### ADDENDUM #4

### Bid 21-109-5211

**For: Providing all materials, equipment, and labor for the rehabilitation, restoration, and renewal of the Big Creek Greenway, Phase 2, from Union Hill Road to Fowler Park, approximately 0.859 miles. We are requesting 3 alternates in construction, timber deck, FRP Deck and concrete deck – it will be at the discretion of the County which solution is chosen.**

CONTRACTOR MUST  
COORDINATE BACKWALL  
HEIGHT WITH ABUTMENT  
DESIGN DRAWINGS

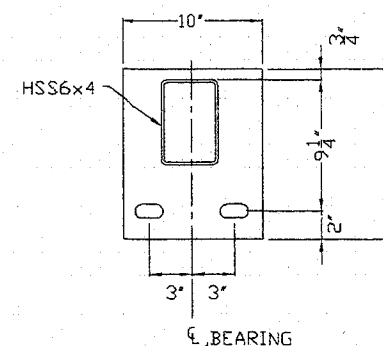
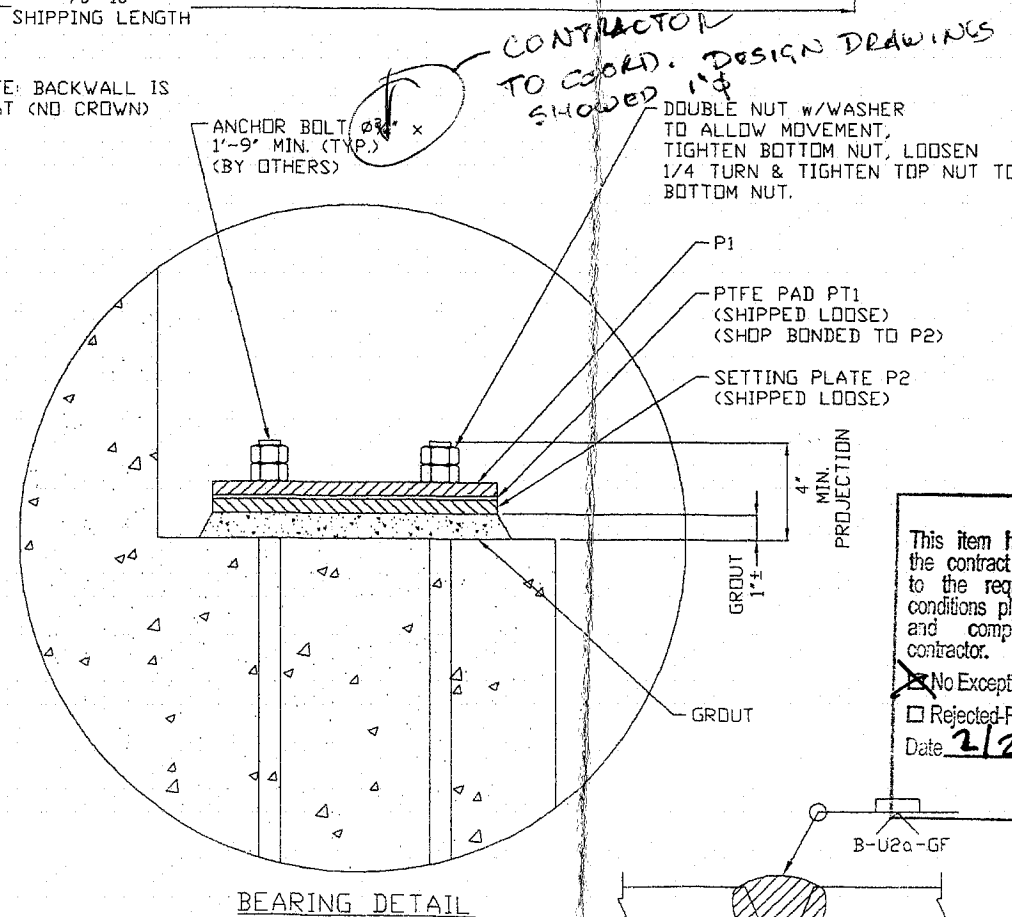
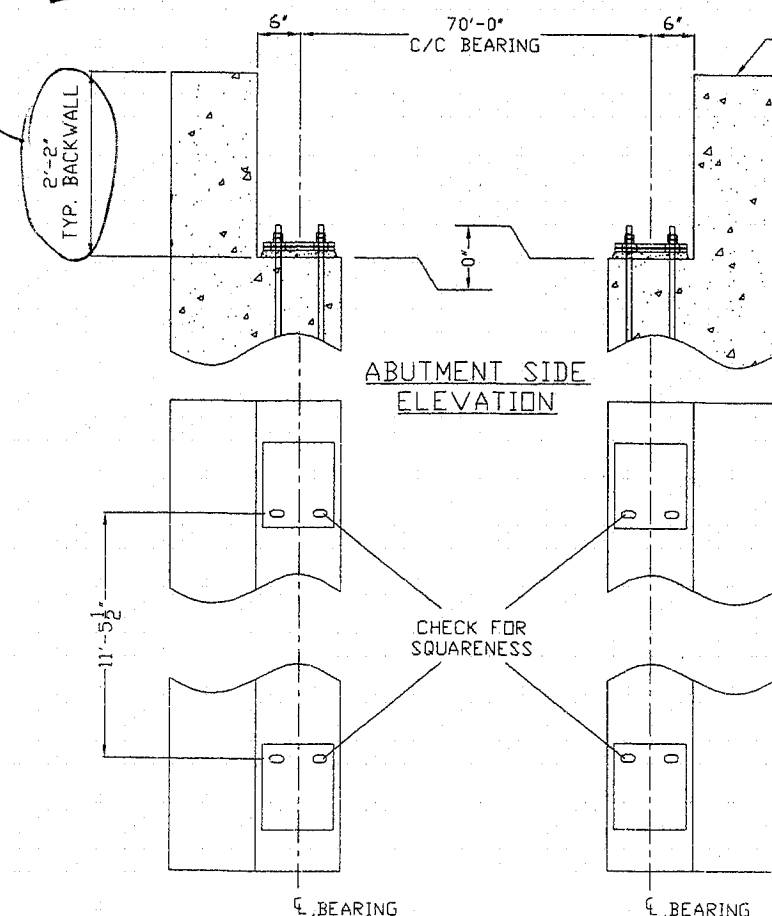
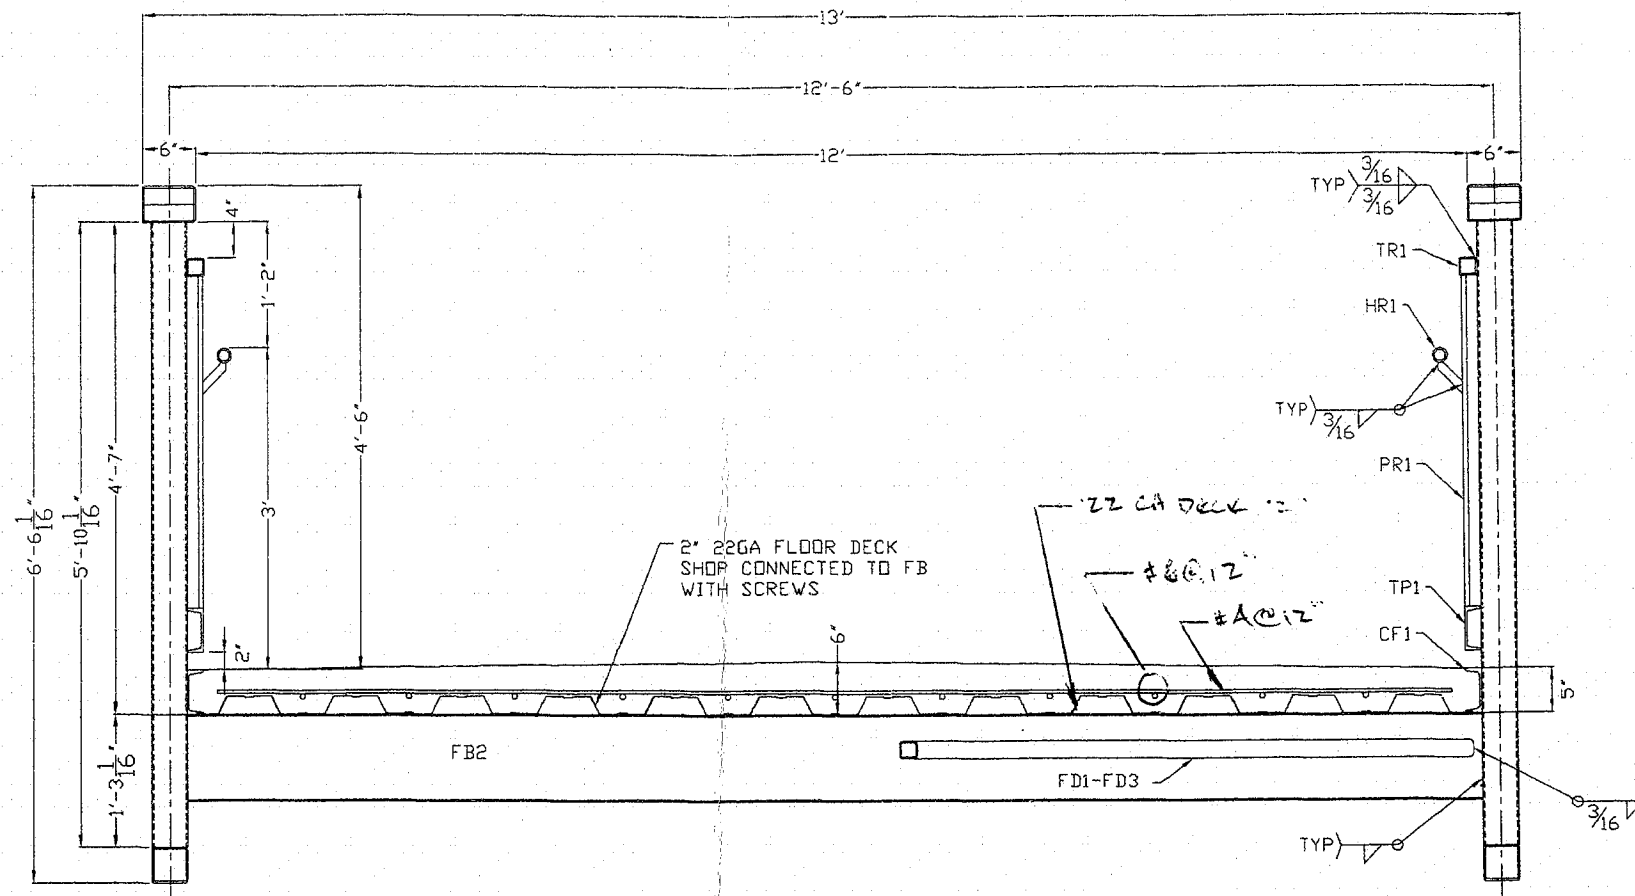
COORD. A.B.  
LOCATIONS
